SPECIAL Meeting Minutes: Plumbing Board

Date: Nov. 6, 2023
Time: 9:30 a.m.
Minutes by: Lyndy Logan
Location: Minnesota Room, DLI, 443 Lafayette Rd. No., St. Paul, MN 55155

A. Possible recommendation of ad hoc Committee on Storm Drainage Surcharge / RFI submitted Oct. 16, 2023

Plumbing Board Request for Interpretation

PLAN VIEW

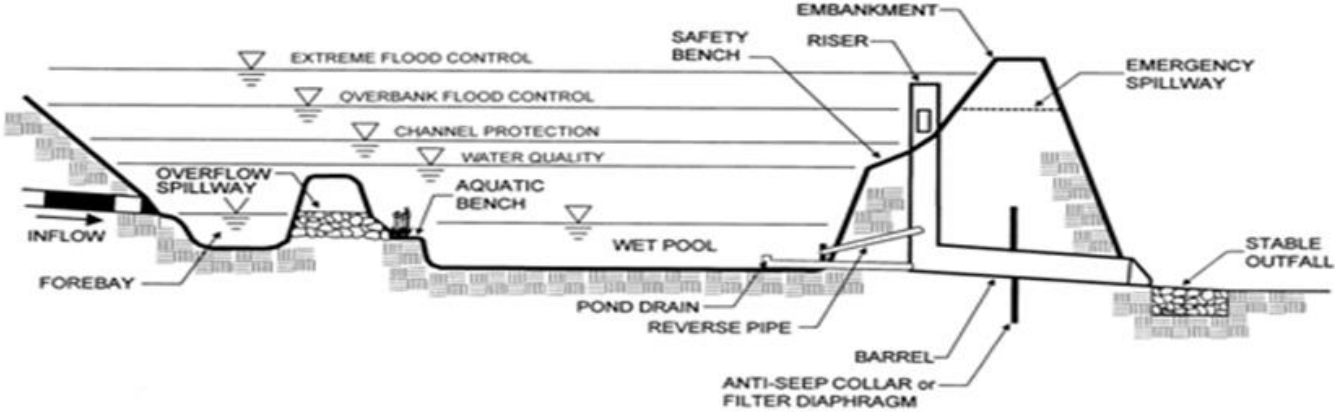
- Dimler referred to the illustrations in **Attachment B** and said at the ad hoc Storm Surcharge Committee meeting they spent a significant amount of time looking at these illustrations. The bottom half of it predominantly where we have towards the bottom of that pool we have what's been put to as the wet pool level and that is where the water will stay at a static level basically and contain that 1800 cubic feet of water from the impervious surface of a construction project. And then the line above that is the water quality level and that is basically where the water would rise to in a one inch rain event which would instantly be attributed to the pond. And in the discussion with MPCA and some of the engineers that were also contributing to that ad hoc committee, who pointed out that if the inlet pipe, which is the inflow pipe shown on the left side of that illustration, if it were raised to be just above that water quality level, that would ensure that that pipe is not surcharging in 90% of the rain events that Minnesota experiences in the course of a year. So, we proposed this for consideration in this RFI as hopefully something of a reasonable middle ground, if you will, between what has been in practice for multiple decades with the pond in that pipe being right at the water level and raising the pipe to a higher level to ensure that at least 90% of the time, that pipe will not be surcharged if it's set at or above that water quality level.

- Abrahamson read the motion from the Oct. 31st Surcharge Committee meeting as follows:
 - A motion was made by Abrahamson, seconded by Wahlen, to accept the invert of the sewer to discharge to the pond at the water quality level to reduce a 90 percent chance of surcharging the sewer, as it pertains to 310.5 and 309.1. The roll vote was unanimous with 5 votes in favor of the motion; the motion passed.

Section 310.5 of the 2020 Minnesota Plumbing Code states that “[n]o fitting, fixture and piping connection, appliance, device, or method of installation that obstructs or retards the flow of water, wastes, sewage, or air in the drainage or venting systems . . . shall be used unless it is indicated as acceptable in this code or is approved in accordance with Section 301.2 of this code.” The obstruction or retardation of flow is known as “surcharge” in the industry. Section 309.1 states that “[d]esign, construction, and workmanship shall be in accordance with accepted engineering practices and shall be of such character as to secure the results sought to be obtained by this code.” The Board determined that an inlet pipe that is above the level attained by the water quality volume, as defined by MPCA guidelines, is designed in such a way so as to both meet accepted engineering practices and is also of such a character as to secure the results sought to be obtained by this code. Therefore, storm sewers designed so that the inlet pipe enters above the level attained by the water quality volume are not considered surcharged by design.
